Pending License Amendment to Homestake Mining
Company Unraium Mill and Tailing Facility
(EDATS: SECY-2008-0473)

**Re: Homestake Mining Company Uranium Mill,
License No. SUA-1471, Docket No. 40-8903**

TECHNICAL MEMORANDUM IN SUPPORT OF MASE LETTER TO NUCLEAR REGULATORY COMMISSION REQUESTING TWO-YEAR DELAY IN APPROVAL OF LICENSE AMENDMENT FOR HOMESTAKE MINING COMPANY URANIUM MILL, SUA-1471, MILAN, NEW MEXICO

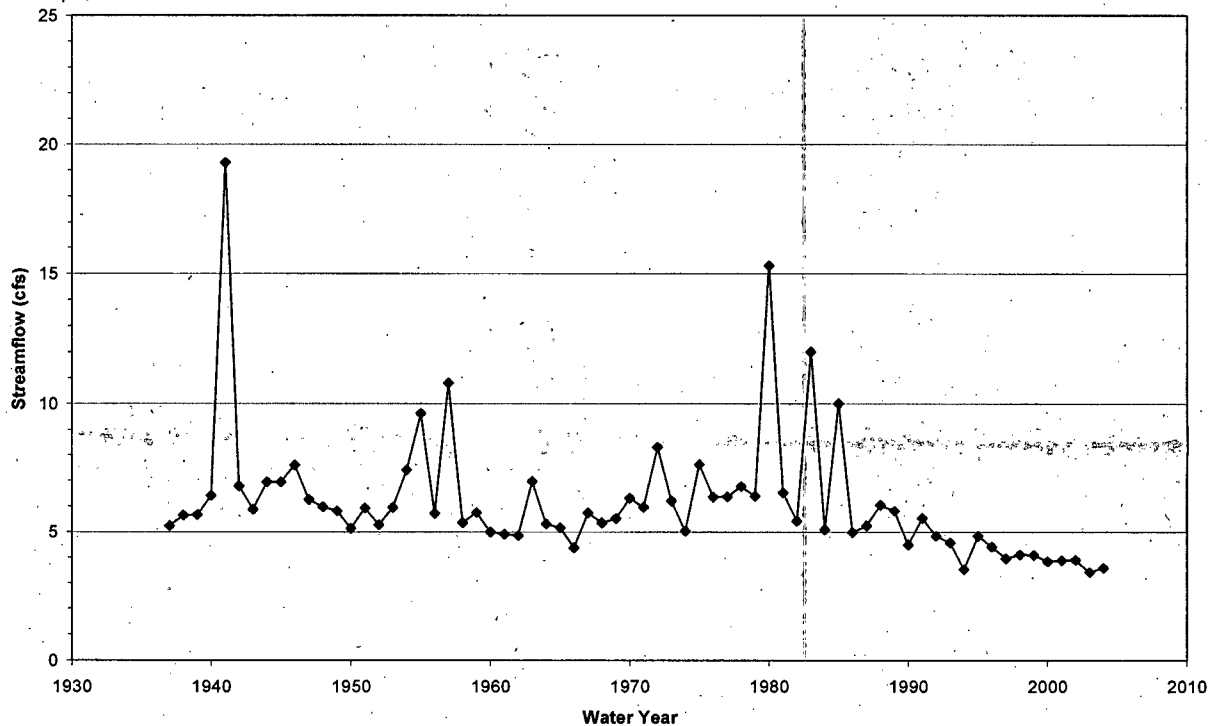
- We calculate that an evaporation pond at least *five times* the size of the proposed EP-3 is needed to treat the 1.15 million gallons per day of contaminated groundwater being pumped from the alluvial and bedrock aquifer down-gradient of the Homestake tailings. A pond or series of ponds even larger than 150 acres may be needed if the flow rates for the injection-pumpback system are increased. Furthermore, the location of a properly sized new evaporation pond should not be over the San Mateo Creek alluvium, as is now proposed for EP-3, even with liners and leak detection systems.
